**Report to the Future Melbourne (Planning) Committee**

**Ministerial Planning Referral TPM-2007-21/B  
1-11 Balston Street (199 City Road), Southbank**

**11 November 2014**

### MINISTERIAL REFERRAL

Drawing Title  
CITY ROAD STREETSCAPE

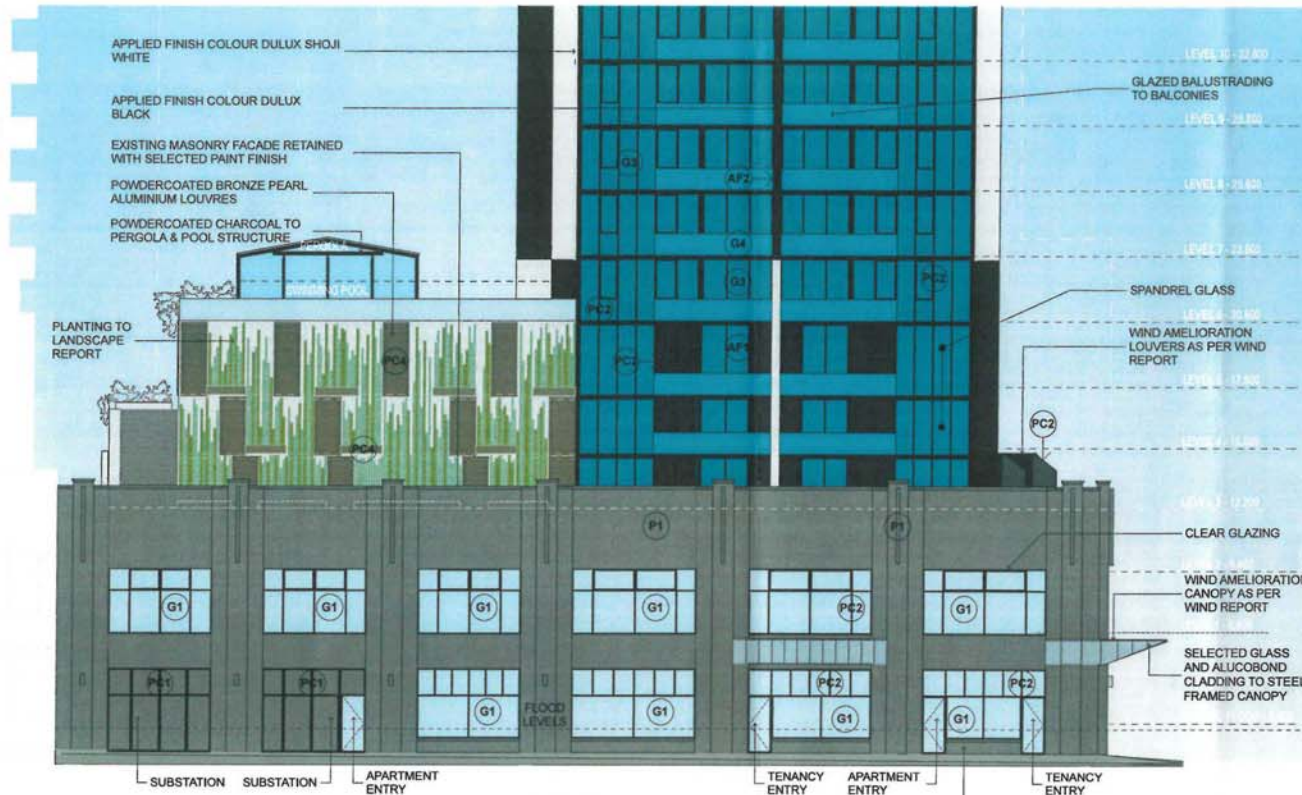
- The infill of the window openings for the substation and the alteration of the sill height will disrupt the constancy of expression across the length of the frontage and will disrupt the appreciation of heritage value of the building.
- The proposed glazed canopies are features that make a substantial statement and would compete with the early building form and distract from the appreciation of that early form.

As a result of the increased building height and increased number of apartments from 382 to 557, the building services have been revised including the relocation and increase in the size of the substation from Balston Street non-heritage fabric (as currently approved) to City Road (refer to figure 6 below).

It is now proposed to accommodate an enlarged substation within two of the existing openings in the City Road remnant heritage façade.

The substation relocation would adversely affect the significance of the heritage place in that it substantially alters the consistency of fenestration expression across the length of the frontage and will disrupt the appreciation of the heritage value of the building. The Building Identification sheet for the site specifically notes the simple fenestration, and it is this fenestration that would be adversely impacted. The infill of two windows is not sympathetic to the architectural character and appearance of the site itself, nor the greater City Road streetscape.

The relocation of the substation into the City Road frontage would also diminish the active street frontage and opportunities for pedestrian interest and engagement. City Road is affected by Schedule 1 of the Design and Development Overlay which specifically encourages active street frontages in major pedestrian areas. Reducing the extent of active street frontages is not supported.

Figure 3. Shadow diagram 22 September @1pm

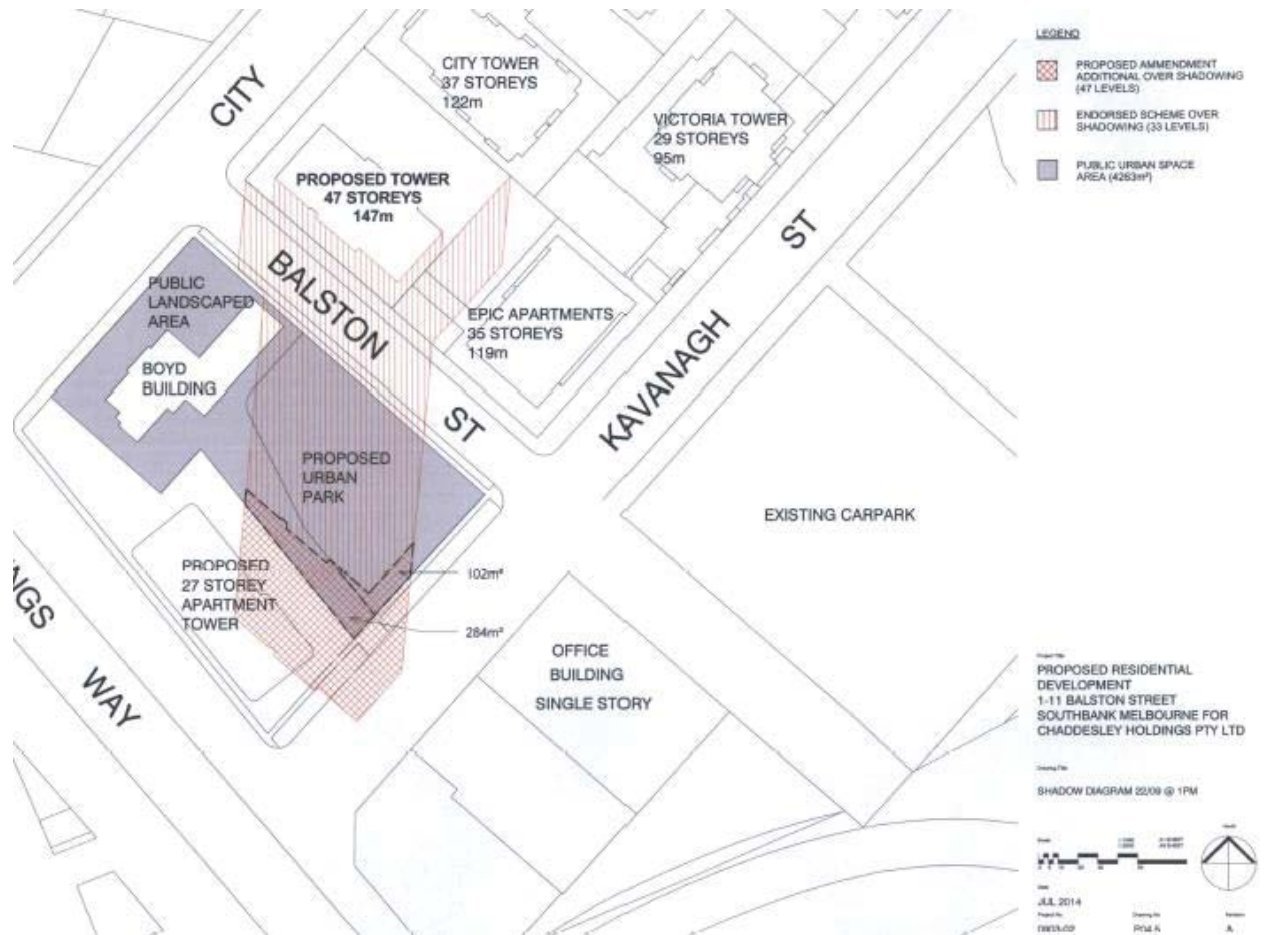
An increased shadow length will result from the proposed increase in height of the building by 14 storeys. Of consequence is the increased overshadowing of the land identified as future urban park as part of the redevelopment of the former JH Boyd School site (opposite on Balston Street).

Shadow diagrams prepared by the applicants compare the shadows cast by the approved development, and the proposed increase in height. These diagrams demonstrate that the increased shadow length will have a direct impact on the future urban park, casting additional shadows, beyond that already approved, at 1.00pm and 2.00pm at the September equinox (refer to figure 3 below).

This reduction in area free from shadow would diminish the enjoyment of this important public space during the times of the year when the intensity of its use would be at its highest.

The Southbank Structure Plan 2010 recognises that ‘the current provision of public open space available for recreational and community uses is low in Southbank’ (page 28). It is therefore imperative that this new public open space remains free from shadow as much as possible.

Figure 4. Recommended inclined awning and baffle screen treatment (source: Windtech report)

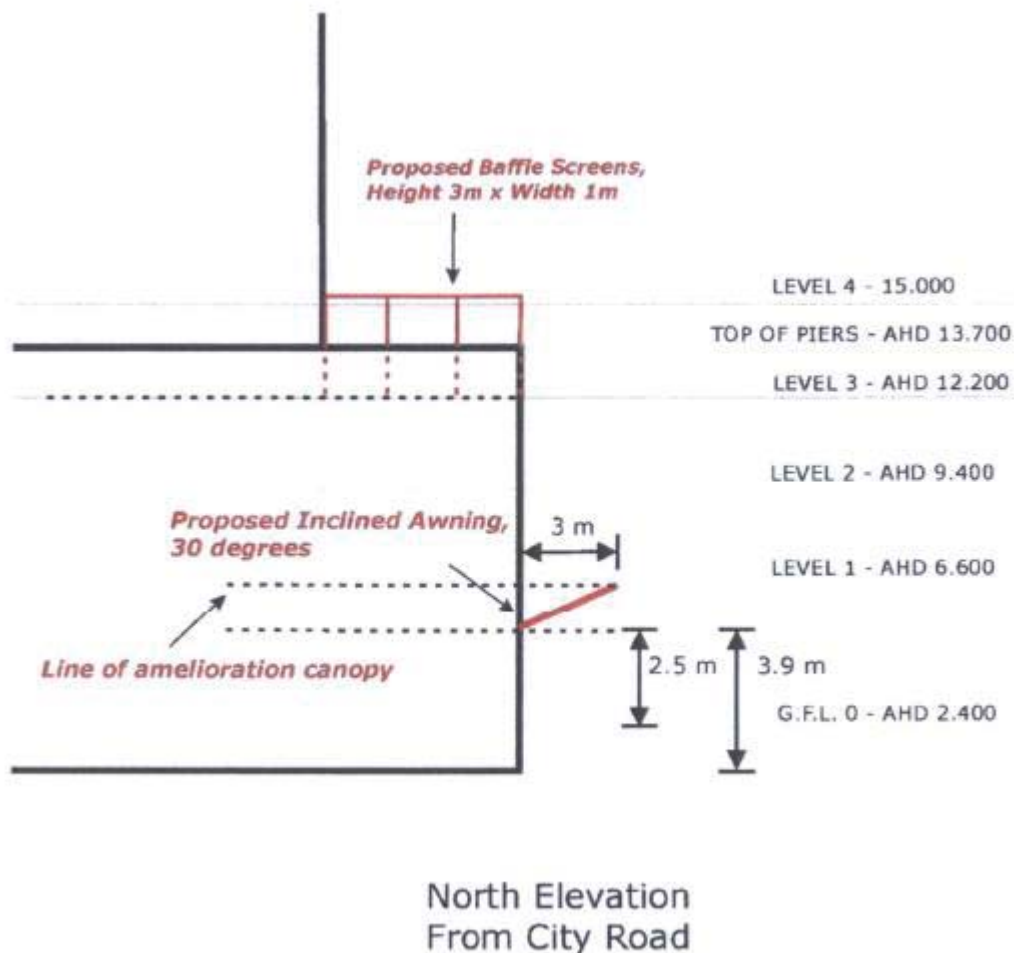
Further, the outdoor terrace area on the podium on the corner of City Road and Balston Street would also experience adverse wind conditions. As such, 3 metre high x 1m wide baffle screens are proposed to be included.

This proposed wind amelioration techniques would ensure that wind conditions meet the fast walking criterion. While not meeting the criterion for development in now required in Southbank, the applicants Wind Consultants advise that:

While accepting that the resultant ground level wind conditions would be the same as that currently experienced on the corner of City Road and Balston Street, the design of the wind amelioration techniques is not acceptable.

The engineered design of the proposed wind amelioration measures are an inappropriate design detail, relating poorly to the heritage façade and adversely affecting its integrity.

Further, the large baffle screens on the outdoor terrace area would compromise the useability of this space by residents, placing large obstacles within an outdoor recreational space.

Figure 5. Perspective corner of City Road and Balston Street - wind amelioration canopy

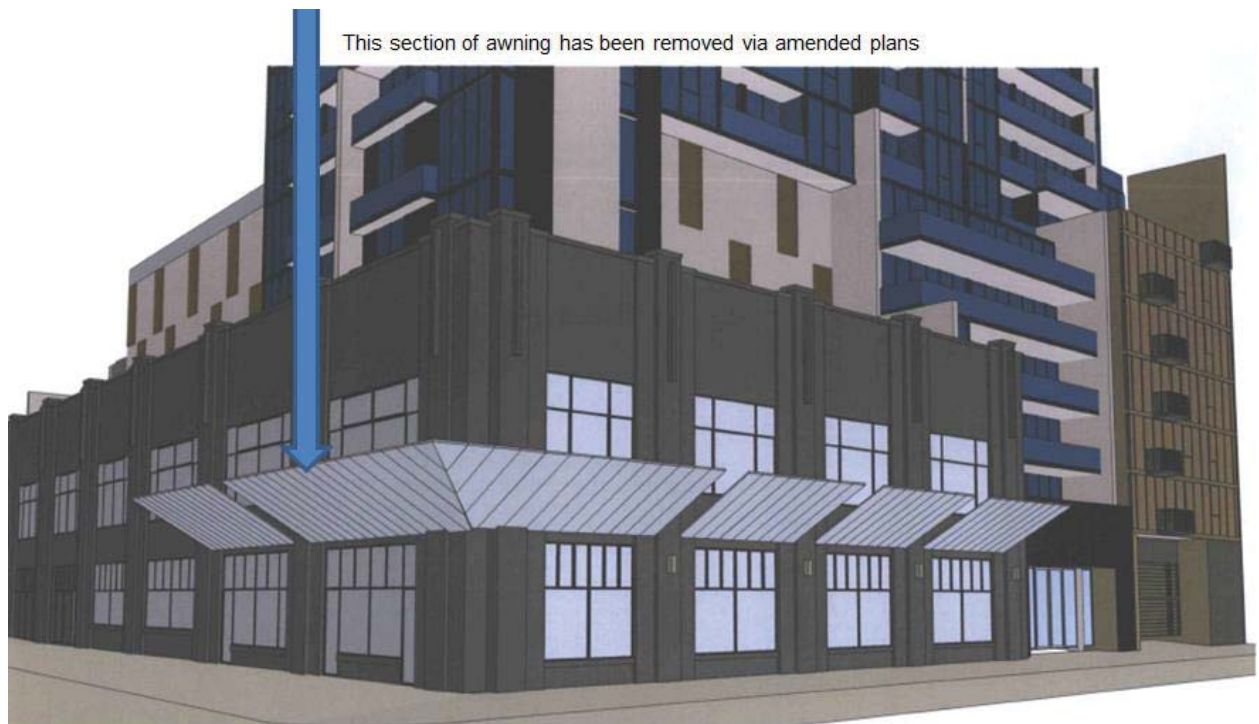
As noted by Council’s Heritage Advisor, the proposed glazed canopies are features that make a substantial statement and would compete with the early building form and detract from the appreciation of that early form. The design of the canopies is not compatible to the building itself, or nearby buildings in either City Road or Balston Street.

As such, the canopies proposed as a result of adverse wind conditions directly caused by the additional height of the tower, should not be supported.
